## AGENDA

Planning Authority Committee Meeting  
Open Portion  
Wednesday, 23 July 2025  
at 4.00 pm  
Council Chamber, Town Hall

7.1	APPLICATIONS UNDER THE HOBART INTERIM PLANNING SCHEME 2015 .....	7
7.1.1	267 Argyle Street, North Hobart - Partial Demolition and New Building for Vehicle Parking .....	7

Type of Report:	Committee
Date of Report:	15 July 2025
Expiry Date:	25 July 2025
Application No:	PLN-HOB-2025-0140
Address:	267 ARGYLE ST NORTH HOBART TAS 7000
Applicant:	ERA Planning and Environment Level 1, 125A Elizabeth Street, Hobart, Tasmania, Australia, 7000
Proposal:	Partial Demolition and New Building for Vehicle Parking
Representations:	Nil
Performance criteria:	Commercial zone – Noise - 23.3.2 P1 Commercial zone – Setback - 23.4.2 P1 Commercial zone – Landscaping - 23.4.5 P1 Potentially contaminated land code – Excavation - E2.6.2 P1 Parking and access code - Number of car parking spaces - E6.6.1 P1 Parking and access code - Landscaping of parking areas - E.6.7.8 P1 Electricity transmission infrastructure protection code - Development of non-sensitive use near substation - E8.7.3 P1 Historic heritage code - Development in a place of archaeological potential - E13.10.1

**Figure 8. Plan of the subject site indicating the areas of excavation and anticipated depth of excavation. The red overlay indicates the area of high archaeological potential. (Source: Praxis Environment archaeological report, page 36)**

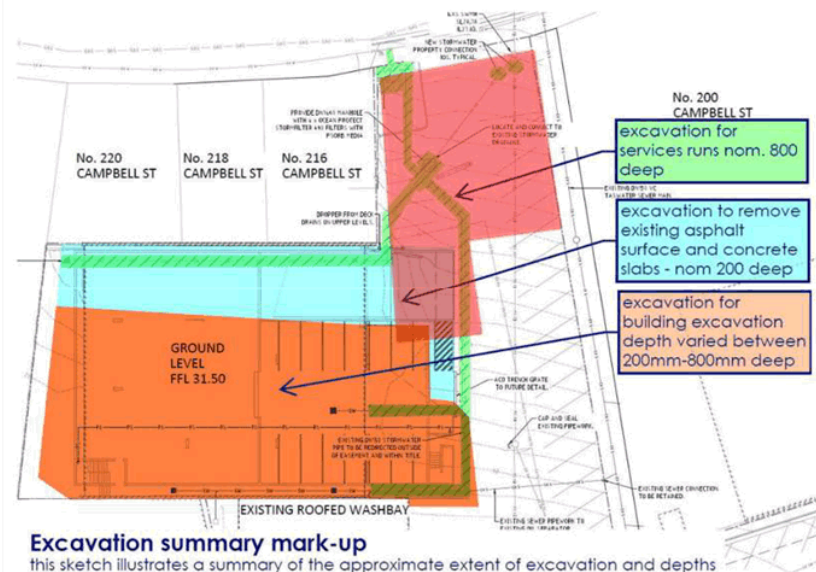
6.15.5	The application was referred to Council's Cultural Heritage Officer, who advised the following:
		<p>267 Argyle Street is identified as a Place of Archaeological Potential in Table E13.4 and Figure E13.4.1 of the <i>Hobart Interim Planning Scheme 2015</i>. It is currently occupied with a ca. 1970s commercial building, although this is known to have replaced a ca. 1845-1870s building which may have also been preceded by a ca. 1830s building. Outbuildings are also associated with the various phases of construction across the site. The <i>Statement of Historical Archaeological Potential, Archaeological</i></p>

Of the works proposed, most of the excavation is to occur outside of the area of high archaeological potential, where the new building will be constructed, although there is a slight overlap of this area and the high potential area. Excavation within the area of high archaeological potential will largely be undertaken for the service runs. According to the archaeological report, 'the depth required [for excavation of the service runs] will certainly be within strata likely to yield archaeological remains' (page 37).

The proposed extent of excavation is included as a markup by Fairbrother of the architectural plans by Preston Lane, in Figure 6.1 of the archaeological report. The red overlay indicates areas of high archaeological potential based on the historical archaeological potential assessment. This figure is reproduced in Figure 1 of this report below:

**RESPONSE TO REQUEST FOR INFORMATION**  
 PROJECT: 267 ARGYLE STREET, NORTH HOBART TAS 7000

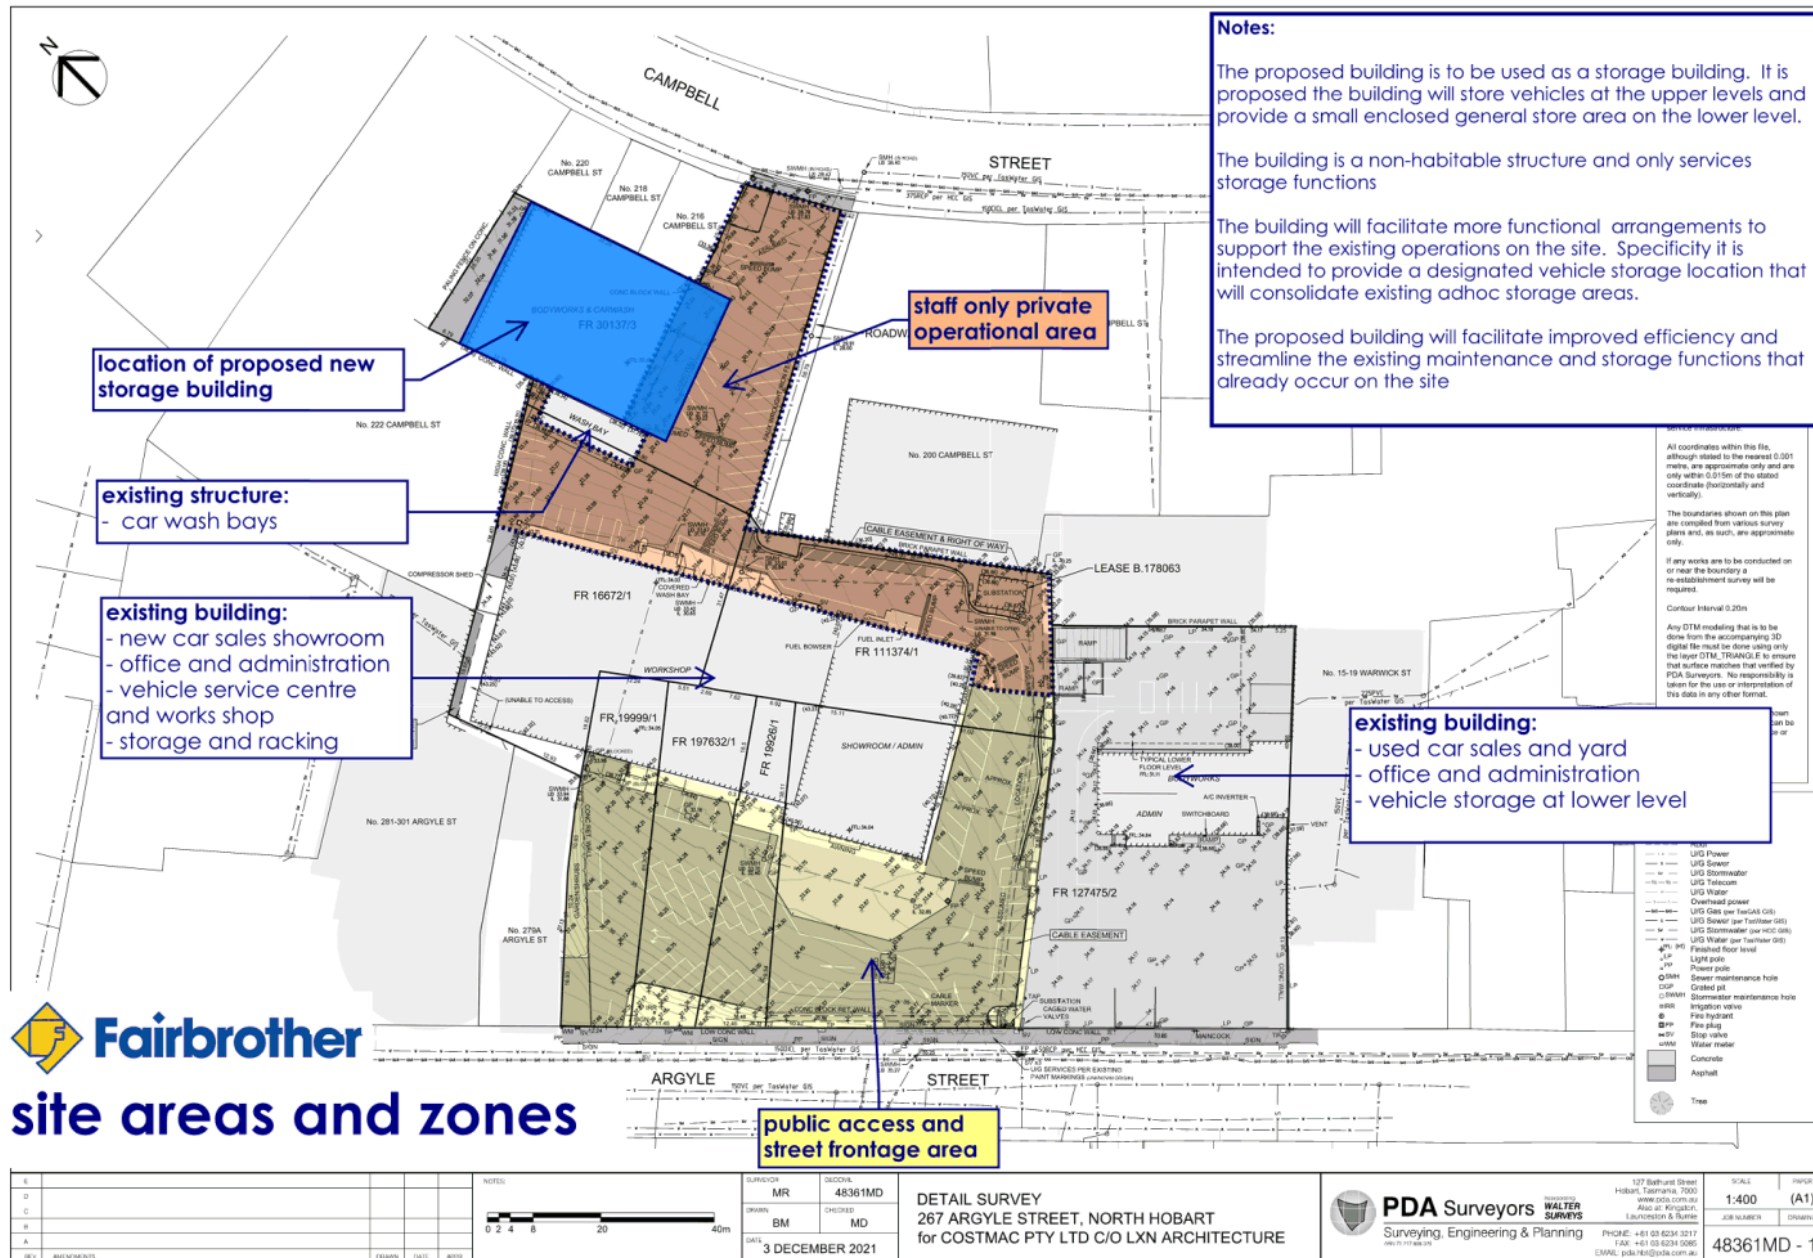
#	REASON	COMMENTS:
5.1	Confirm the anticipated extent of excavation for the entire works, including new stormwater and fire supply lines as well as the new building. Please provide the anticipated depth and area of these works.	Please refer updated <b>SoHAP, AIA &amp; AMS</b> document.

5.2	Provide an amended Statement of Archaeological Potential (SoAP) to reference any excavation required for the new stormwater and fire supply lines, and to reflect the proposed building footprint. It is noted that the SoAP by Praxis Environment dated 20th January 2025 does not appear to reference the works documented in the Gandy and Roberts drawings C020, C050 and C060. It also does not appear to assess the excavation required for the new building as per the 'line of proposed building' in the documentation by Preston Lane Architects, drawings A01-00 and A01-50, which extends further south than the current building.	Please refer updated <b>SoHAP, AIA &amp; AMS</b> document.

6.0	<b>E6.7.5 - Parking and access Code - Design of Parking Areas</b> To satisfy Hobart Interim Planning Scheme 2015 clause E6.7.5, please provide scaled and dimensioned drawings prepared by a suitably qualified expert to address all aspects of the acceptable solution or performance criteria. Advice:

7.0	<b>E6.7.13 - Parking and Access Code - Commercial Vehicles</b> To satisfy the Hobart Interim Planning Scheme 2015 clause E6.7.13, please address all aspects of the acceptable solution or performance criteria by a suitably qualified expert. Advice:
